### **Application No.: PL8889**

Description :	
Address :	
Record Type :	PLAT

<b>Document Filename</b>
01 MASTER PLAT APPLICATION.pdf
SWQMP REV.pdf
SUNSET RIDGE MASTER PRELIM PLAT REV2-3-26.pdf
UTILITY PLAN.pdf

**STORMWATER MANAGEMENT PLAN**

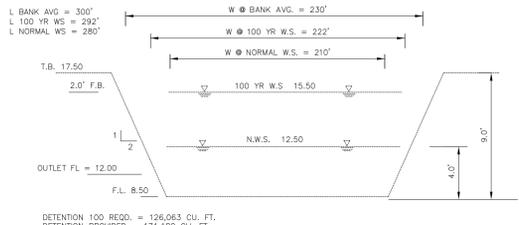
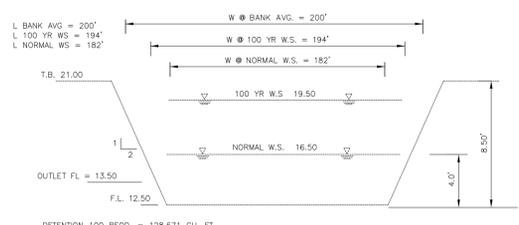
25	SWQMP	Note	Alex Harmon : DS	Closed	This is a snippet from the old master plan. The City Council adopted a new stormwater master plan in 2024.	
26	SWQMP	Note	Alex Harmon : DS	Closed	<p>Per City of Corpus Christi - Code of Ordinances Ch. 14, Art.X, Sec. 14-1003, a Storm Water Quality Management Plan (SWQMP) is required. The following information is not included with the submittal:</p> <p>-Hydraulic calculations based upon established procedures (such as the rational method). This should be done for the predveloped land and post developed land.</p>

Comment ID	Page Reference	Annotation Type	Author : Department	Status	Review Comments	Applicant Response Comments
27	SWQMP	Callout	Alex Harmon : DS	Closed	Verify EOR is okay with concentration for pre and post development being the same. Generally, Tc decreases with paved route vs meandering open fields.	
6	U001	Note	Mina Trinidad : DS	Closed	<p>(Informational) Fire: (Comments 1-6)</p> <p>1. While currently existing as an OCL tract, annexation is forthcoming and this plat will need to meet UDC, Water a Fire Standards</p> <p>2. Water Distribution Standards: Fire flow for residential areas require 750 GPM with 20 psi residual</p> <p>3. 507.5.1 Exception 1: Group R-3 (one- or two-family dwellings): Fire hydrants to be located every 600 feet apart.</p> <p>4. 3310.1 Required access. Approved vehicle access for firefighting shall be provided to all construction or demolition sites. Vehicle access shall be provided to within 100 feet of temporary or permanent fire department connections. Vehicle access shall be provided by either temporary or permanent roads, capable of supporting vehicle loading under all weather conditions. Vehicle access shall be maintained until permanent fire apparatus access roads are available.</p> <p>5. D102.1 Access and loading. Facilities, buildings, or portions of buildings hereafter constructed shall be accessible to fire department apparatus by way of an approved fire apparatus access road with an asphalt, concrete or other approved driving surface capable of supporting the imposed load of fire apparatus weighing at least 75,000 pounds.</p> <p>6. 503.1.1 (amendment) Buildings and facilities: During construction, when combustibles are brought on to the site in such quantities as deemed hazardous by the fire official, access roads and a suitable temporary supply of water acceptable the fire department shall be provided and maintained.</p>

Verify EOR is okay with concentration for pre and post development being the same. Generally, Tc decreases with paved route vs meandering open fields.

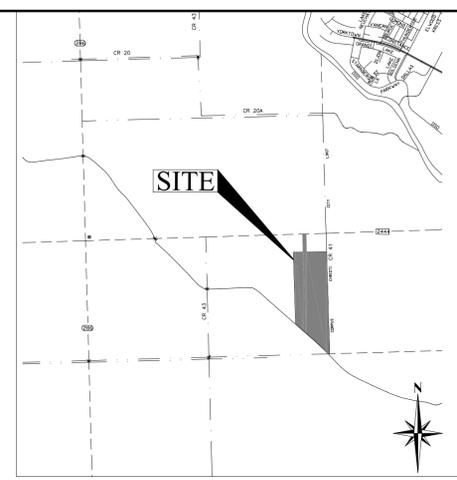
5	P001	Note	Mina Trinidad : DS	Closed	<p>12/17/25 Update: Ziba A: Closes within acceptable engineering standards.</p> <p>GIS: Plat does not close within acceptable engineering standards.</p>	
12	P001	Note	Mina Trinidad : DS	Closed	<p>(Informational as the following is not reviewed until Preliminary and Final phases)</p> <p>AEP: AEP Texas Distribution is requesting 5' electrical easement off every ROW in the subdivision.</p>	
13	P001	Note	Mina Trinidad : DS	Closed	(Informational) Equistar Pipeline will not be involved with PL8889 and has no additional comments.	
14	P001	Note	Mina Trinidad : DS	Closed	Traffic/ROW: (Comments 1-10)

Comment ID	Page Reference	Annotation Type	Author : Department	Status	Review Comments	Applicant Response Comments
					<p>1. Proposed Driveway access to public City Street shall conform to access management standards outlined in Article 7 of the UDC (UDC 7.1.7)</p> <p>2. The developer / applicant can reach out to rowmanagement@cctexas.com for further assistance regarding the ROW Construction Permit they will be required to submit prior to any temporary and / or permanent driveway off the immediate roadways.</p> <p>3. The ROW Construction permit must be submitted and approved prior to any form of construction within City ROW.</p> <p>4. Any contractor working within City ROW without an approved ROW Construction Permit can be held in non-compliance and can be subject to a fee of \$1,500 per day of unpermitted work, as per City of Corpus Christi Municipal Code 49-112 (9).</p> <p>5. Proposed driveway access to a public maintained by the Texas Department of Transportation (TXDOT) shall conform to TXDOT criteria. The developer and/or agent is responsible for coordination with the local TXDOT Area Office.</p> <p>6. The PW-Traffic Department (Right-of-Way Division) is responsible for reviewing and permitting new construction and repairs/modifications to driveways, sidewalks, curb, and gutter. The review and approval of the permit must be approved prior to the issuance of the building permit (issued by DSD). (Refer to Municode Chapter 49-30 for permit requirements.)</p> <p>7. Public improvement plans shall include all signage and pavement markings needed for traffic operations (e.g. signage, striping, traffic mitigation devices) in addition to standard "regulatory" STOP and street name blade sign installations. Additionally, cul-de-sacs must include either "NO OUTLET" or "DEAD END" signage. Temporary Dead-Ends should include the appropriate object markers and one-way streets must include signage for any one-way designations and affected side streets. Reference: Texas MUTCD based on CC UDC Article 8.1.3.A</p> <p>8. Pavement markings shall be installed within the scope of the subdivision in accordance to specifications of, and subject to, latest version of the "Texas Manual on Uniform Traffic Control Devices (TMUTCD), public improvement plan reviews and inspections, by the City. Reference: Texas MUTCD and UDC Article 8.1.3.A</p>

Comment ID	Page Reference	Annotation Type	Author : Department	Status	Review Comments	Applicant Response Comments
					<p>9. Pavement markings shall be installed within the scope of the subdivision on all streets classified as a collector (C1) or higher on the City's Urban Transportation Plan Map. Streets not designated as a collector (C1) or higher but constructed with a 40-foot width (back-of-curb to back-of-curb) will be subject to specifications stated in public improvement plan review. Reference: Texas MUTCD based on CC UDC Article 8.1.3.A</p> <p>10. All traffic signs shall be furnished and installed by the Developer in accordance to specifications of, and subject to, latest version of the "Texas Manual on Uniform Traffic Control Devices (TMUTCD), public improvement plan reviews and inspections, by the City. This includes furnishing and installing "STOP" signs. Reference: Texas MUTCD based on CC UDC Article 8.1.3.A. All entries to private streets from public streets shall be clearly signed by the owners or homeowners' association as a "private street." (Reference UDC Article 8.2.1.J. Private Streets)</p>

15	P001	Note	Mina Trinidad : DS	Closed	<p>Traffic/ROW: (Comments 11-18)</p> <p>11. The developer or their representative is required to submit a "Street Lighting Plan", indicating the proposed locations and fixture type of streetlights, for review and approval to the City's Traffic Engineering Department. All new fixture types will be LED. Streetlights shall meet design requirements per the City of Corpus Christi Infrastructure Design Manual (IDM) Chapter 8 - Street Lighting Design Policy and Guidelines.</p> <p>12. The "Street Lighting Plan" shall indicate all existing streetlights within 500-ft (+/-) of proposed streetlights along tangent street sections. Preliminary "written" approval of the "Street Lighting Plan", by the City's Traffic Engineering Department, is required before the utility company (AEP or NEC) can start the design of the street lighting system and determine developer fees, which are required for plat recordation. Traffic Engineering issues a Letter of Authorization to the utility company, allowing for construction of the street lighting system, once this process is complete.</p> <p>13. An Urban Transportation Plan Amendment is required to modify or delete a master planned street. Coordinate with the Traffic Department (TrafficEngineering@cctexas.com) to complete this separate process and requirements.</p>

Comment ID	Page Reference	Annotation Type	Author : Department	Status	Review Comments	Applicant Response Comments
					<p>14. A ROW Construction Permit, issued by PW-Traffic Department (Right-of-Way Division), is required for any work obstructing, closing, or occupying public right-of-way (Reference Chapter 49-2). Work within the Right-of-Way without a permit is subject to daily Non-Compliance Fees (Reference Municode Chapter 49).</p> <p>15. Provide the PHT form using 11th edition, or latest edition, of the Trip Generation Manual . A PHT Form is required for any rezoning, site plan or street closure request for developments that are projected to contain 500 or fewer weekday peak hour trips. A traffic impact analysis will be required for developments generating or 501 trips. (Reference UDC Section 3.29)</p> <p>16. Any street excavation, utility cut, or utility tap requires a permit issued by the Traffic Department (Right-of-Way Division). Restoration requirements are subject to the street Pavement Condition Index (PCI) and street age.</p> <p>-New streets ( Any street 0-6 years and / or PCI <math>\geq</math> 80) will require restoration of 25-ft beyond the outermost edge of the excavation and up to curb-to-curb repair.</p> <p>-Older streets (Any street &gt; 6 years or PCI &lt; 80) will require restoration of 10-ft beyond the outermost edge of the excavation and up to full lane (Refer to Municode Section 49-47-1).</p> <p>17. Sidewalks required on both sides of local street as per IDM Chapter 6 - Street Design Requirements. Table 6.2.2 Street Right-of-Way Dimension Standards</p> <p>18. Culd-de-Sacs shall conform to access management standards outlined in Article 8 of the UDC (UDC 8.2.1 G)</p>

17	P001	Note	Alex Harmon : DS	Closed	Provide easements on lot frontage of 10'. (front 5' UE and back 5' EE)	
24	P001	Note	Alex Harmon : DS	Closed	Although typical street cross sections are not required until the preliminary plat, note that this plat has two routes on the UTP - one adjacent to the plat and one through the plat. Any requested deviations will need a UTP amendment through ROW.	
32	P001	Note	Mina Trinidad : DS	Closed	(Informational) Planning: Property is currently not annexed nor zoned with the City.	
33	P001	Note	Mina Trinidad : DS	Closed	<p>(Informational as fees are applied at Preliminary Plats)</p> <p>Parks and Recreation: 157 (Dwelling units proposed) x \$462.50 (Fee) = \$72,612.50</p> <p>Plat describes the proposed use of lots to convert to single-family residency. Total number of proposed dwelling units equals (157). As such appropriate fees have been applied, at a rate of \$462.50 by the 157 proposed units. If this number of proposed units changes, please update as to allow proper reflection of fees, if changes were to</p>

Comment ID	Page Reference	Annotation Type	Author : Department	Status	Review Comments	Applicant Response Comments
					occur. Parks and Recreation Fee Document is uploaded into your customer portal.	
34	P001	Note	Mina Trinidad : DS	Closed	Remove drainage arrows within Master Preliminary Plat.	
35	P001	Note	Mina Trinidad : DS	Closed	Number the general notes.	
36	P001	Note	Mina Trinidad : DS	Closed	Darken the phase line within the development. Ensure the phases allow for full lots.	
37	P001	Note	Mina Trinidad : DS	Closed	Narrow down the number of lots that are proposed for each phase.	
38	P001	Note	Mina Trinidad : DS	Closed	(Informational) C3 Primary Collector Street through property.	
39	P001	Note	Mina Trinidad : DS	Closed	(Informational) South of property in Flood Zone AE.	
40	P001	Note	Mina Trinidad : DS	Closed	(Informational) If a Homeowners Association is to be established, provide a legal instrument that establishes a plan for maintenance and supervision of such improvements per UDC 8.1.8. Home Owners Association.

48	P001	Note	Mina Trinidad : DS	Closed	(Informational) Fire - Smith Choi: Fire Department would like to make the follow-up comments for the above-captioned plat. 1. Fire Department would require a 96 feet diameter for the temporary Cul-De-Sec in your phase 1 Development . Please show it on preliminary plat. 2. Fire Department would require 2 points of access for phase 1 that exceed 50 units lot and that 2 access point must meet the remoteness requirement of 2021 IFC. 3. Please clarify if Phantom Drive is existing or proposed. Fire Department may not accept proposed access. If it is existing and is used for second access, it must meet remoteness requirement. 4. As to Phase II Development, Fire Department require 96 feet diameter Cul-Del Sec . 5. Clarify the timeline of the future C3 Collector sheet. 6. Phase II Development also require two point of access as phase 1.	
49	P001	Note	Mina Trinidad : DS	Closed	Please see the following Traffic comments: ROADWAY MASTER PLAN: A2 Arterial (North / South), east side of proposed development, continuation of County Road 41 (Gilead Road) 50 FT ROW dedication proposed in the Plat - future

Comment ID	Page Reference	Annotation Type	Author : Department	Status	Review Comments	Applicant Response Comments
					<p>development on the east side would require the other 50 FT ROW dedication to complete full ROW dedication.</p> <p>ROW Dedication adhering to Roadway Master Plan - 100 FT ROW dedication, as per Roadway Master Plan (RPM)&amp; Infrastructure Design Manual (IDM) Public improvements, construction required (half street) as per UDC Chapter 8 &amp; IDM Chapter 6 Updated plat to show street typical for County Road 41 (Gilead Road) extension for review and approval (should show number of through lanes) Typical section as per IDM Table 6.2.2.b Non-Local Street Standards Table &amp; UDC Section 8.2.1.B Street ROW Dimensional Standards for proposed extension of County Road 41 (Gilead Road) County Road 41 (Gilead Road) would require public improvements to meet external connectivity requirements outline in UDC Section 8.2.1.D. External Connectivity</p> <ul style="list-style-type: none"> <li>o Two (2) points of external access, minimum, must be provided if the development has more between 81 to 160 buildable lots in a subdivision.</li> <li>o Three (3) points of external access, minimum, must be provided if the development has more than 161 buildable lots in a subdivision.</li> </ul> <p>As per UDC Section 8.2.1.E Street layout. Add note: Block 4, Lots 1 – 15 &amp; Block 9, Lots 1 – 16 prohibited driveway access to proposed A2 Arterial - County Road 41 (Gilead Road)</p> <p>C3 Collector (East / West), center of proposed development, connection to County Road 41 (Gilead Road) 75 FT ROW dedication proposed – for future C3 collector street ROW Dedication adhering to Roadway Master Plan - 75 FT ROW dedication, as per RMP &amp; IDM Connectivity proposed for future development to the East &amp; West (between County Road 41 &amp; 43) Connectivity adhering to Roadway Master Plan, as per RMP &amp; IDM Updated street typical to show number through lanes, as per IDM Table 6.2.2.b Non-Local Street Standards Table &amp; UDC Section 8.2.1.B Street ROW Dimensional Standards</p>

Comment ID	Page Reference	Annotation Type	Author : Department	Status	Review Comments	Applicant Response Comments
					<p>Adhering to legacy UTP - 75 FT ROW dedication  As per IDM Table 6.2.2.b Non-Local Street Standards Table &amp; UDC Section 8.2.1.B Street ROW Dimensional Standards  No on-street parking allocated for a C3 Collector, proposed section of roadway between Blocks 6 &amp; 7  o Traffic recommends mitigations outline in Section 8.2.1.E Street Layout (#3) to accommodate proposed development fronting C3 collector.  If you have any further questions, please feel free to contact ROW / Traffic at your convenience.</p>	
58	P001	Note	Mina Trinidad : DS	Closed	<p>(Informational) Fire:  (Chief Juan Perez)  All code reference is based on currently adopted International Fire Code (IFC) 2021 and Corpus Christi Water Distribution Standards  Information purposes only: Although this subdivision is considered outside city limits. Consideration should be given to the minimum standards for fire protection as follows:</p> <p>Utility:  Residential fire flow should have at least 750 GPM with fire hydrants spaced every 600 feet.</p> <p>Information:  If a property gets platted that is OCL and within the City's CCN District for Water (drawn up by State Law), they are subject to obtaining water. If the feasibility of water is such that it can be required, the development is instructed to build out the water mains. If it is not feasible, other means of fire protection must be provided (Well/Tank/Pump etc.)</p> <p>503.2.3 Surface. Fire apparatus access roads should be designed and maintained to support the imposed loads of fire apparatus and shall be surfaced to provide all weather driving capabilities and capable of supporting the imposed load of fire apparatus weighing at least 75,000 pounds.</p> <p>IFC 2015 Sec. 503.2.1 Dimensions Fire apparatus access roads shall have an unobstructed width of not less than 20 feet, exclusive of shoulders.</p>

21	P001	Note	Caleb Wong : STREET	Closed	PW STR: Informational - A person shall be held responsible for damage to and in public right-of-way for the criteria outlined in Sec. 49-39-9 in the City's Municipal Code and will be held responsible for restoring the City assets per Municipal Code Sec. 49-47-1, Sec. 49-54-6 and Sec. 49-49-3. For further information, please email ROWManagement@cctexas.com.	
22	P001	Note	Caleb Wong : STREET	Closed		
23	P001	Note	Caleb Wong : STREET	Closed	PW STR: Will CR 41 be built out to connect to the proposed streets?	
41	P001	Note	Justin Phung : STREET	Closed	PW STR: Please label any private streets to assist in reviewing.	
42	P001	Note	Justin Phung : STREET	Closed	PW STR: The developer shall be required to utilize the most stringent of sections per classification of roadway without a Geotech report validating the soil type. Please refer to IDM when constructing pavement section.

43	P001	Note	Justin Phung : STREET	Closed	PW STR: CR 41 is labeled as a secondary arterial (A2) per the Legacy Urban Transportation Plan. Please coordinate with the Public Works Traffic Department to ensure the proper ROW dedication is allocated. In addition, please provide a typical section for CR 41.	
44	P001	Note	Justin Phung : STREET	Closed	PW STR: Please refer to City of Corpus Christi Standards and Specifications for proposing roadwork, curb and gutter, sidewalk, utilities, etc and have the standards included in the plan set and the specifications referenced. CoCC Standards don't show a Type "L" curb.

Comment ID	Page Reference	Annotation Type	Author : Department	Status	Review Comments	Applicant Response Comments
45	P001	Note	Justin Phung : STREET	Closed	PW STR: IDM Table 6.3.5N provides details for using PCCP for construction of the street while the typical section shows HMA being used. Please confirm and correct the typical section to show the proper typical section and notes.	
46	P001	Note	Justin Phung : STREET	Closed	PW STR: Please denote where the private maintenance ends for streets off the C3 collector.	
47	P001	Note	Justin Phung : STREET	Closed	PW STR: Will CR 41 be built out to S Staples St.?	
50	P001	Note	Justin Phung : STREET	Closed	PW STR: Informational - If street is private it must adhere to UDC 8.2.1.J Standards	
51	P001	Note	Justin Phung : STREET	Closed	PW STR: Per IDM table 6.3.5H, the treated subgrade and flexible base shall extend at least 2 feet beyond the back of curb.	
52	P001	Note	Justin Phung : STREET	Closed	PW STR: Per IDM Table 6.3.5H, the road section cross-slope from the crown to the gutter shall be a consistent 2% minimum.

53	P001	Note	Justin Phung : STREET	Closed	PW STR: Per IDM Table 6.3.5J, One coarse surface treatment/underseal would be required between the base and asphalt pavement.	
54	P001	Note	Justin Phung : STREET	Closed	PW STR: Informational - Project should address the vertical alignment of the proposed tie-ins to existing infrastructure inside and outside project limits. Vertical alignment should not restrict flow to inlets and should allow smooth riding surface. If current project limits don't allow this, the project limits should be altered to address.	
55	P001	Note	Justin Phung : STREET	Closed	PW STR: Informational - Vertical alignment of side streets should not protrude into higher classification roadways.	
56	P001	Note	Justin Phung : STREET	Closed	PW STR: Please provide clarification on the construction and material used for the A2 median.	
57	P001	Note	Justin Phung : STREET	Closed	PW STR: Who will be responsible for the mowing of the A2 and C3 streets?
